GROVE CITY, OHIO - CITY COUNCIL Agenda

August 4, 2025

202501020002
Autumn Grove Section 6 Phase 2
Plat
PID: 040-012465

202506160020
Parkway Centre (Marlane)
Arcadia Tower Site
Special Use Permit
PID: 040-005957

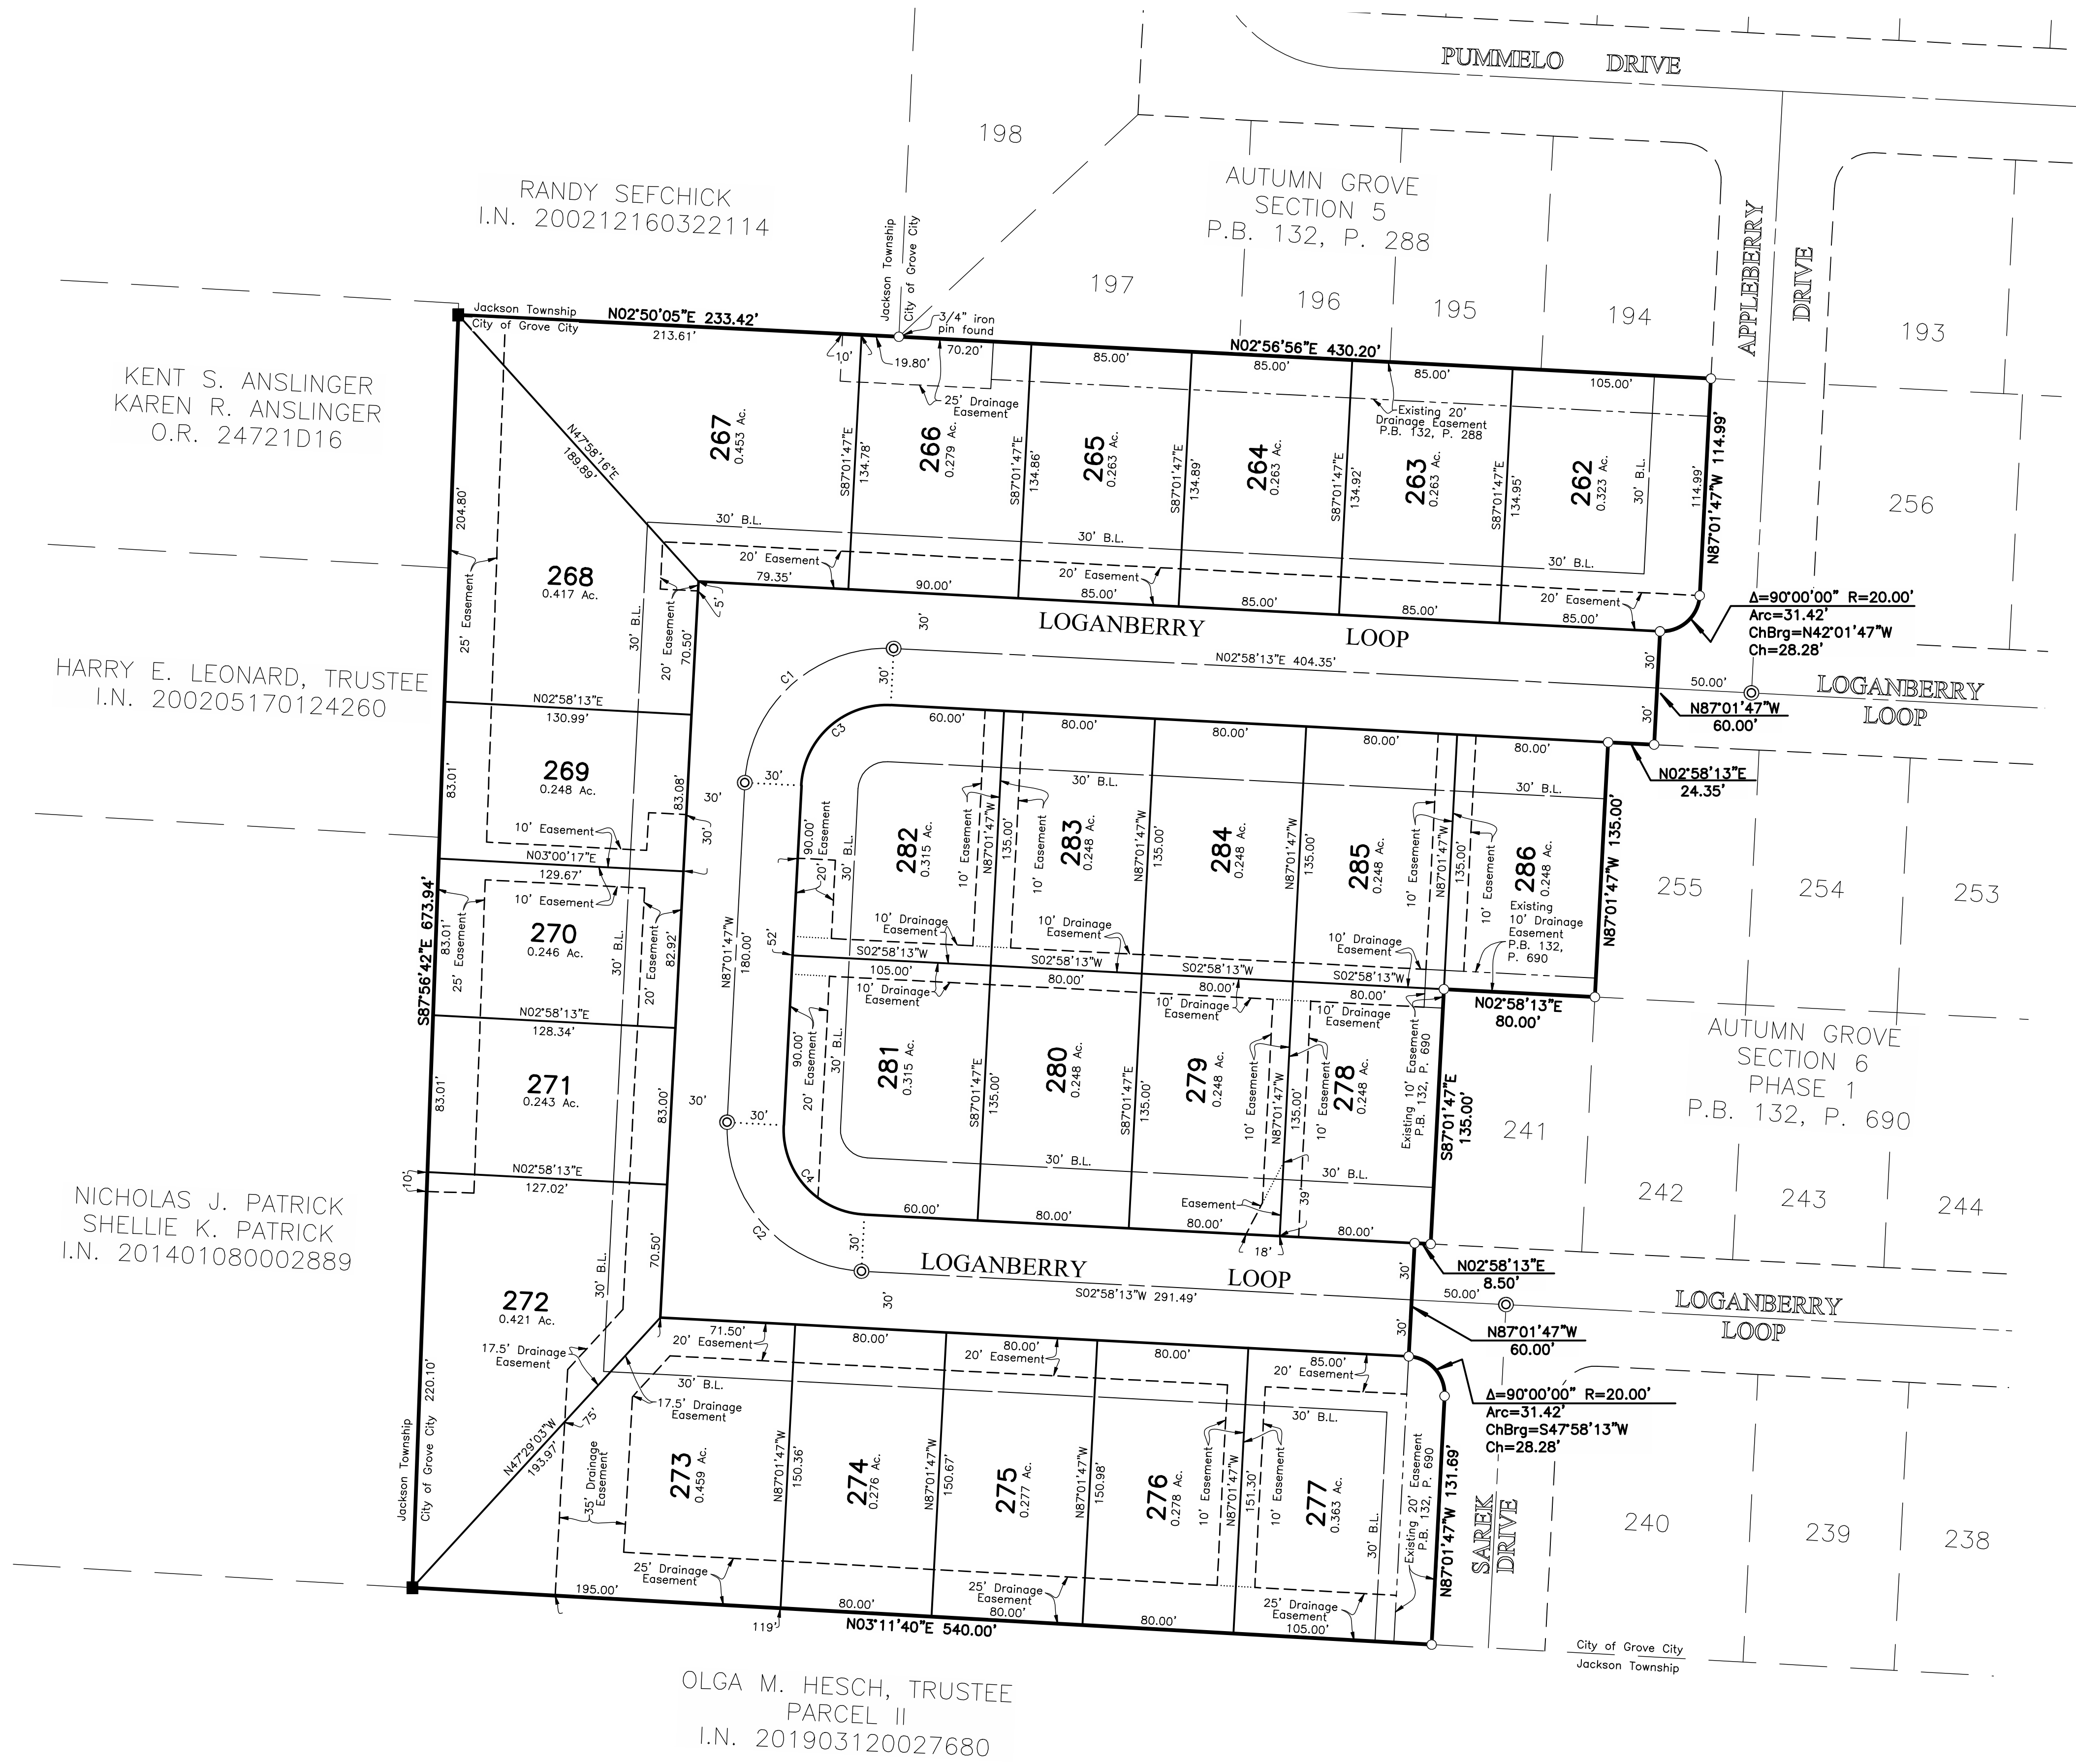
1. Please revise the easement distance on Lot 282.
2. Label 25' easement on lot 266 as "drainage easement" as labeled on the construction drawings.
3. Label the existing 10' easement on lot 286 as "drainage easement" as indicated on the Phase 1 Plat.

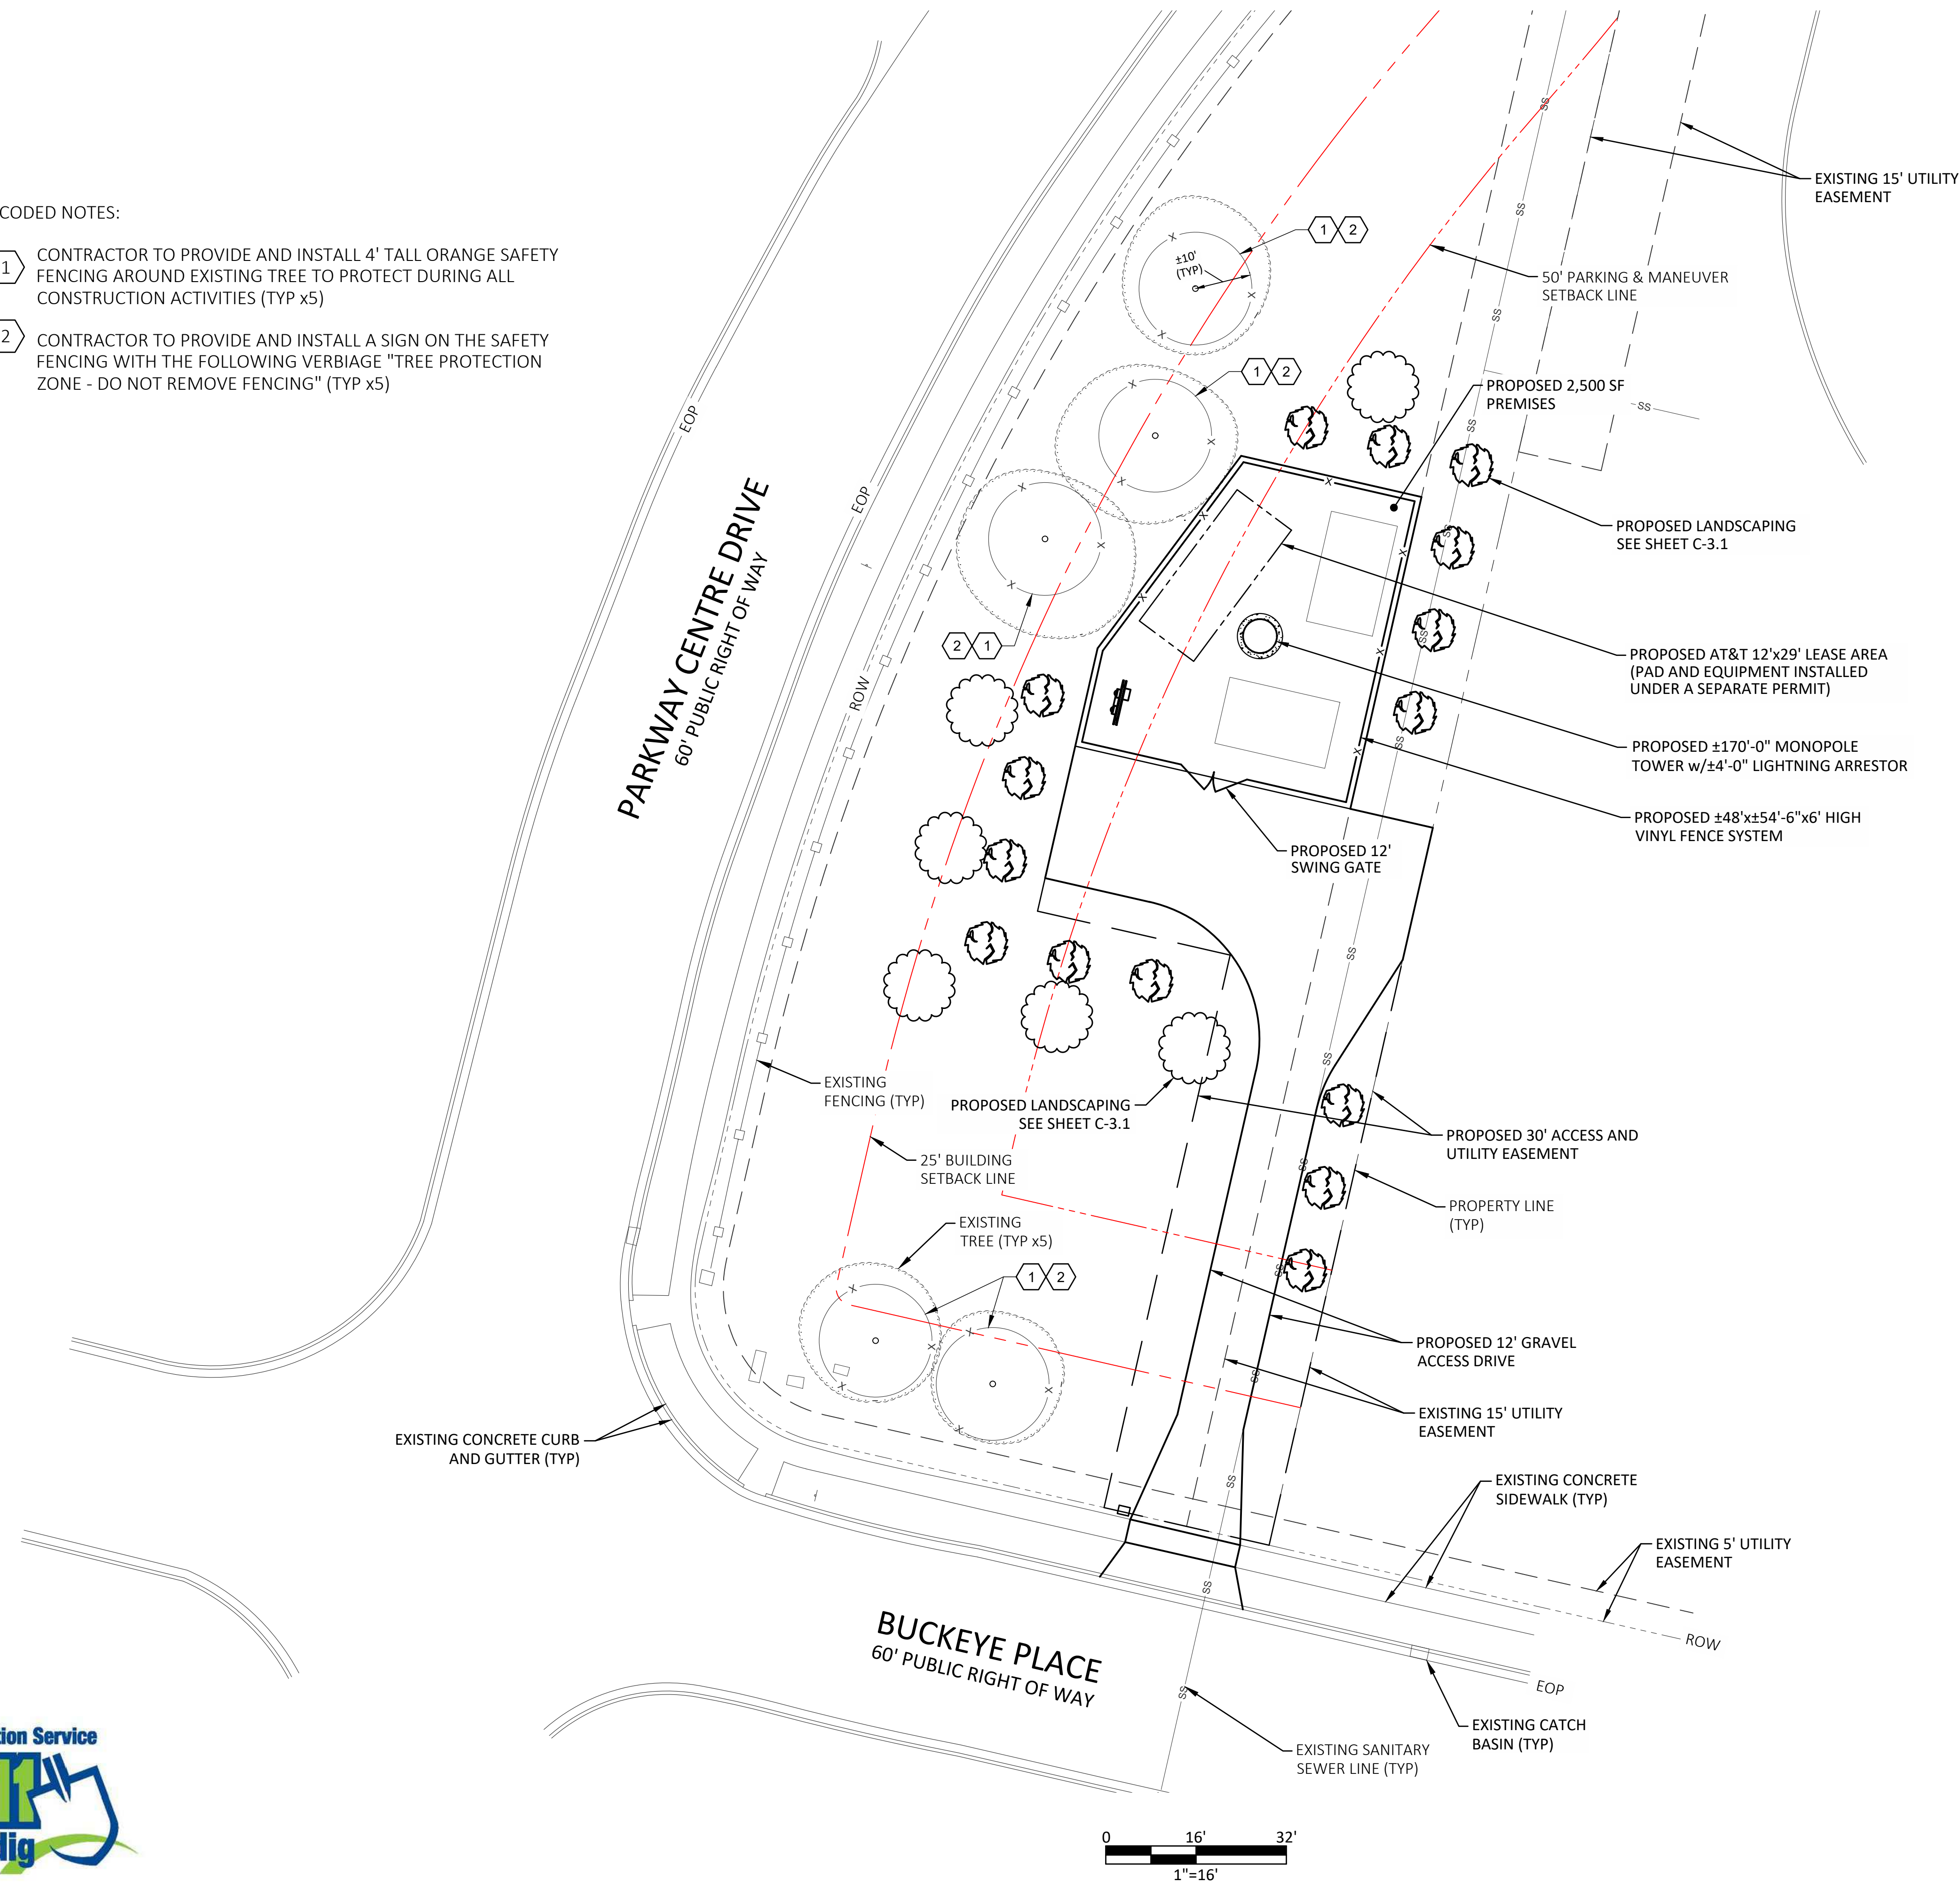
1. Please add an additional Blue Spruce along the east side of the gravel drive south of the fenced area. ***The additional Blue Spruce has been added to the plans see attached C-3.1 in the construction plans showing the additional Blue Spruce.***

2. A Tree Preservation Plan should be submitted showing fencing and signage locations around the existing trees on the site to be preserved. ***I have attached a revised page of the plans listed as Tree Preservation Plan C-3.2 in the construction plans showing the tree preservation program.***

3. The landscape plan should be amended to note that 50% of the burlap and wire cage are to be removed from the root ball of all trees. ***I have attached a revised page of the plans under tree planting detail where this provision is listed in the construction drawings on page C-3.1.***

4. The City's Urban Forester recommends replacing the proposed Redbuds with a different species, as Redbuds do not do well with full sun exposure. ***On page C-3.1 we have revised the species from Redbud to a Flowering Dogwood.***
